INVITATION TO TENDER "ITT" PS20170704 SUNSET PARK UPGRADE

ADDENDUM NO. 3

June 19, 2017

3. DRAWING L-03A: Demolition and Tree Retention Plan

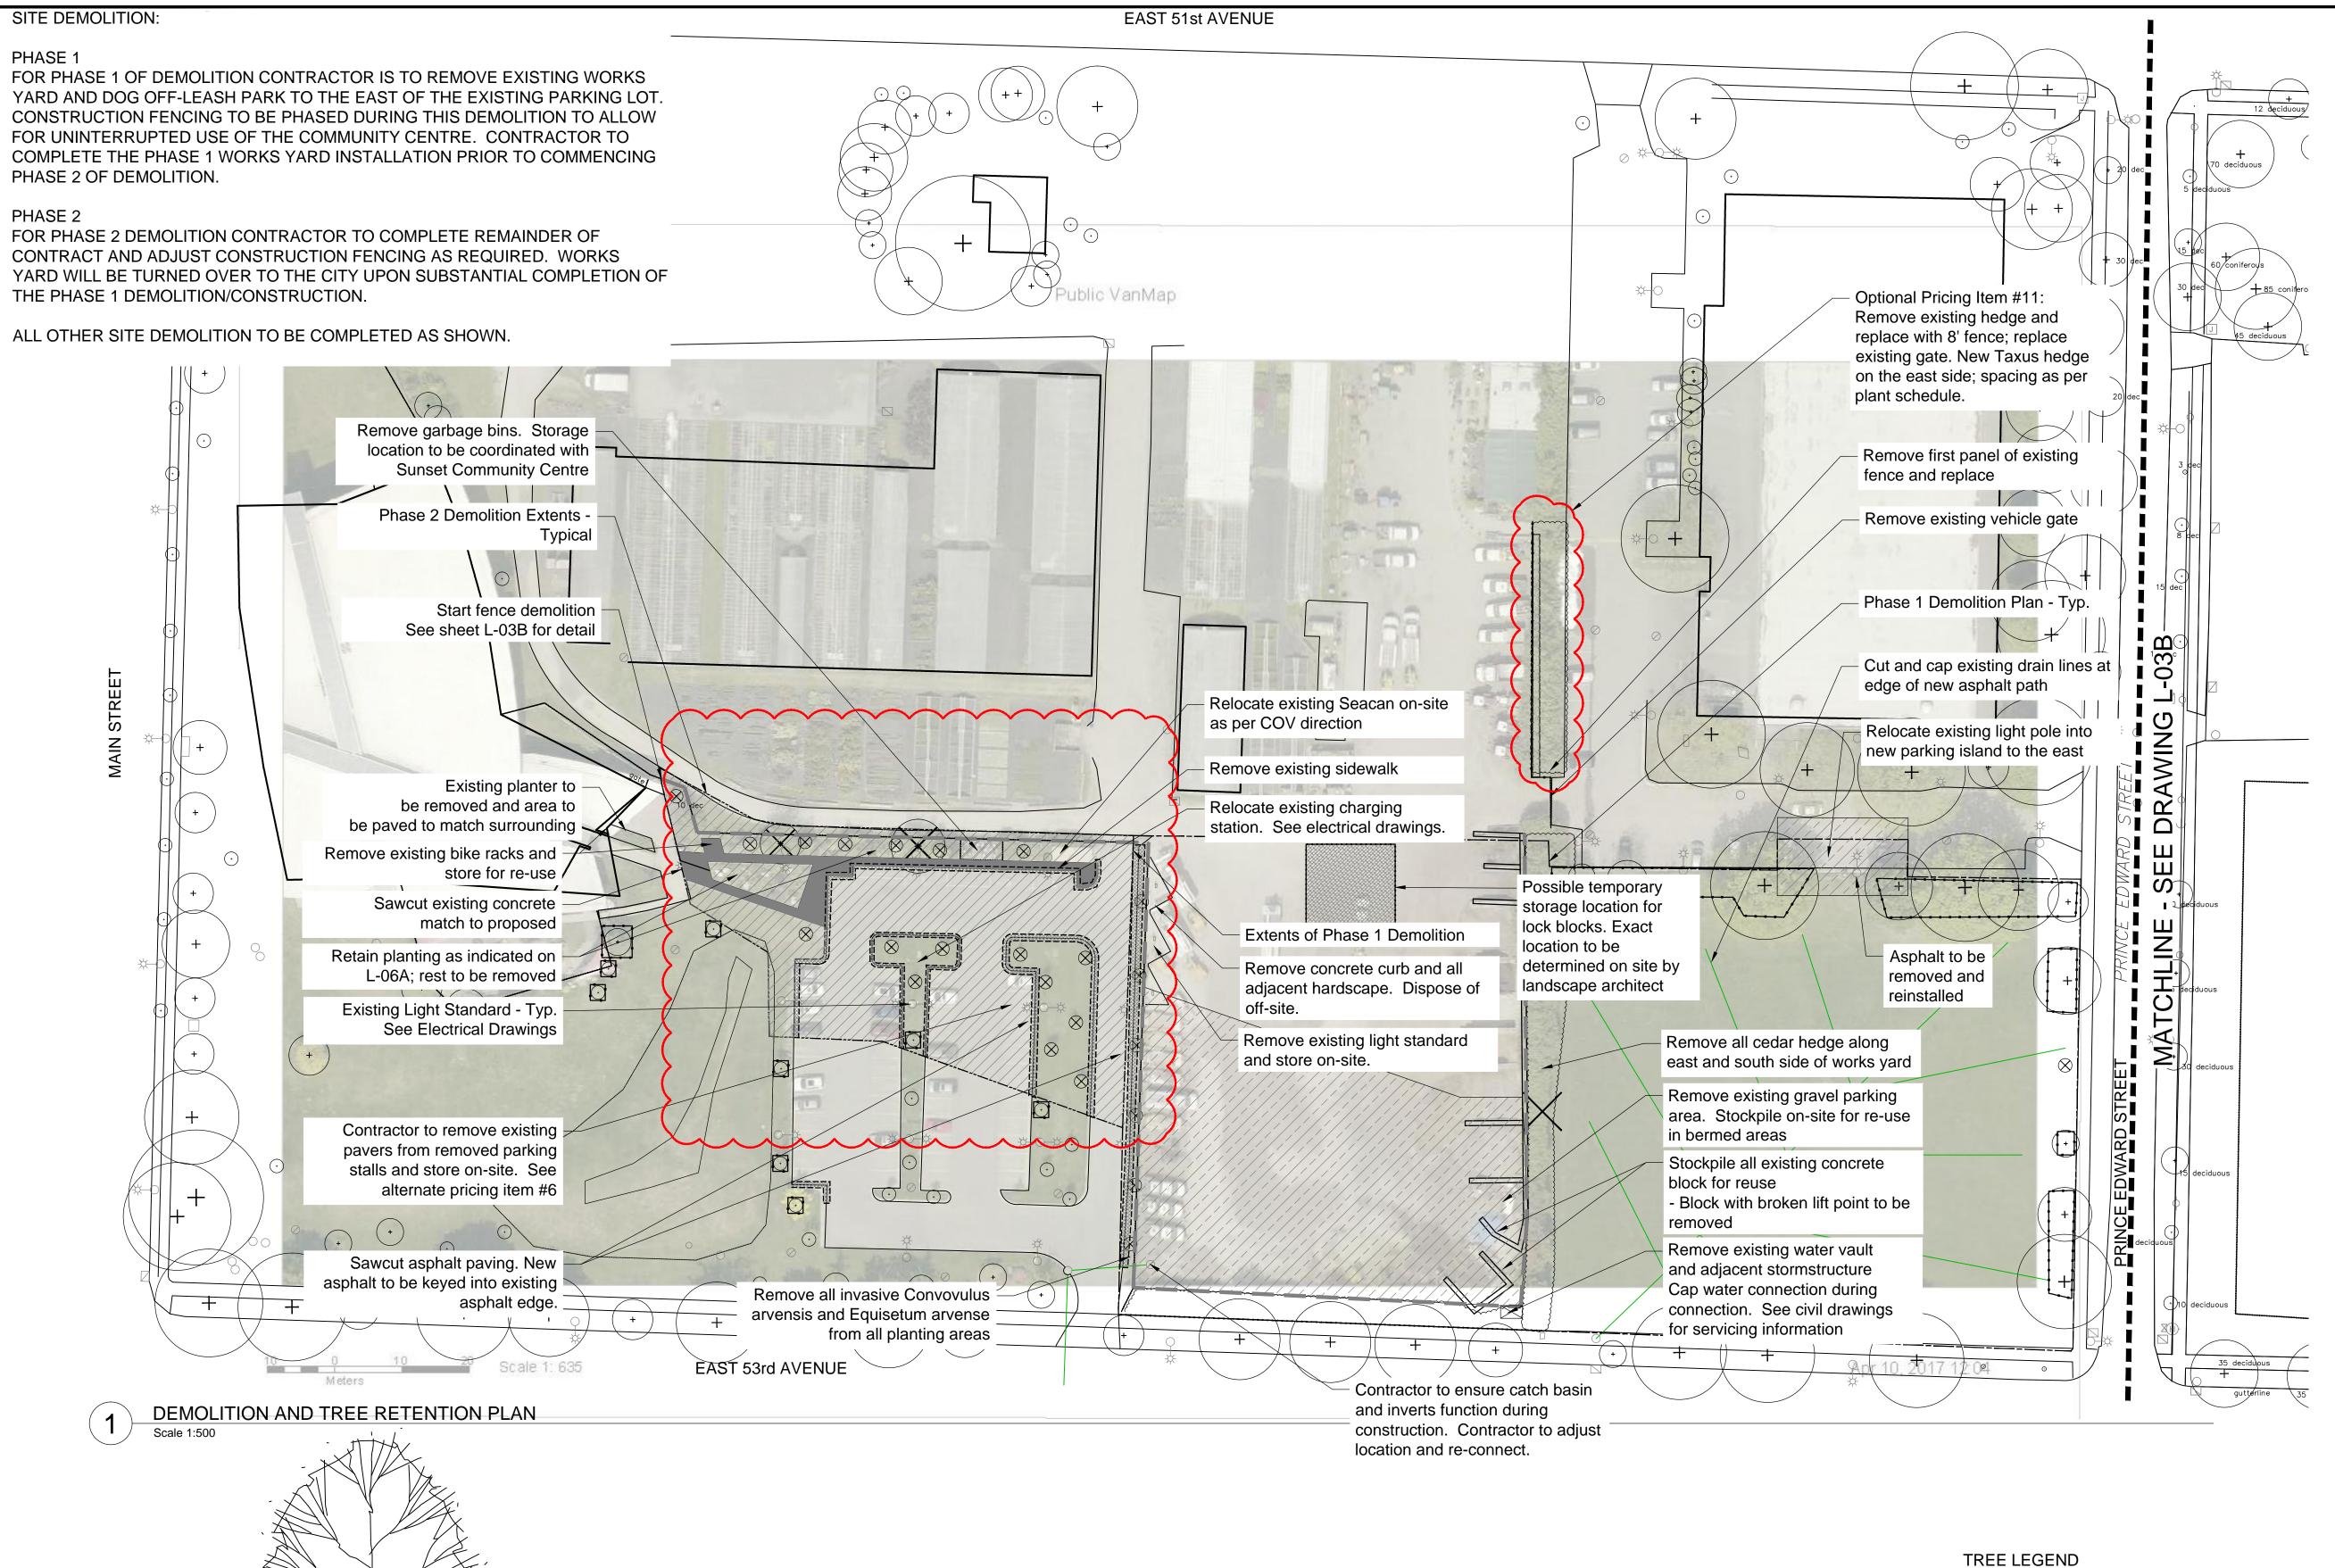
Temporary lock block storage location has been clarified. Existing parking lot removal boundary has been adjusted. All adjacent landscape and curb to be removed as well to match cut line with proposed plan.
